## Application for Licence

### Part V Division 3 of the *Environmental Protection Act 1986*

<b>Licence Number</b>	L9417/2023/1
<b>Applicant</b>	Kumina Iron Pty Ltd
<b>ACN</b>	169 725 973
<b>File number</b>	DER2023/000657
<b>Premises</b>	Onslow Camp Dunes Shire of Ashburton Legal description - M08/488, G08/80, L08/127 and Pastoral Lease 3114/905
<b>Date of report</b>	13/03/2024
<b>Proposed Decision</b>	Licence granted

**Figure 2: Relationship between SAR and EC of irrigation water for prediction of soil structural stability. Note that 1 dS/m = 1,000  $\mu$ S/cm**

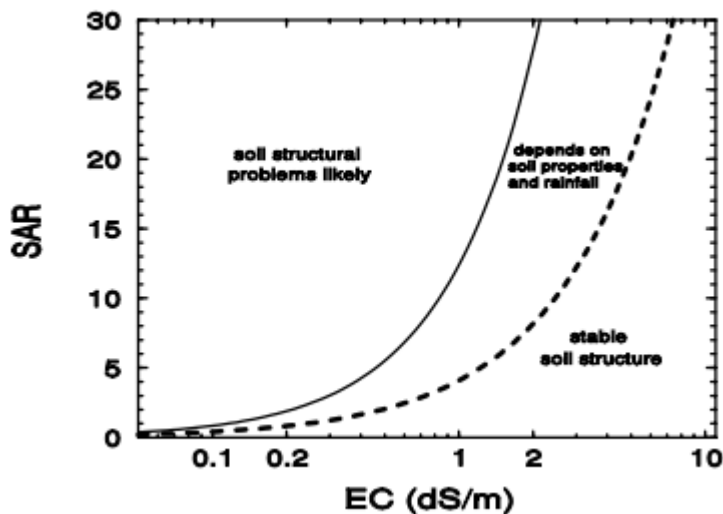
RO Brine was sampled on 30 January 2024 and analysed for SAR and EC. Laboratory results indicated:

- SAR = 7.3
- EC = 4,900  $\mu$ S/cm (4.9 dS/m)

Additionally, the combined treated effluent and RO Brine was sampled on 18 January 2024, laboratory results indicated:

- SAR = 6.2 and 6.1 respectively
- EC = 3,100  $\mu$ S/cm (3.1 dS/m) and 3,700  $\mu$ S/cm (3.7 dS/m) respectively.

The NSW 2004 indicates that a SAR greater than 6 is likely to raise exchangeable sodium percentage (ESP) of soils. The EC of the RO Brine and the EC of the combined TWW are considered high water salinity rating, however the relationship between SAR and EC of irrigation water are considered satisfactory for irrigation purposes for prediction of soil structural stability as per Figure 2.
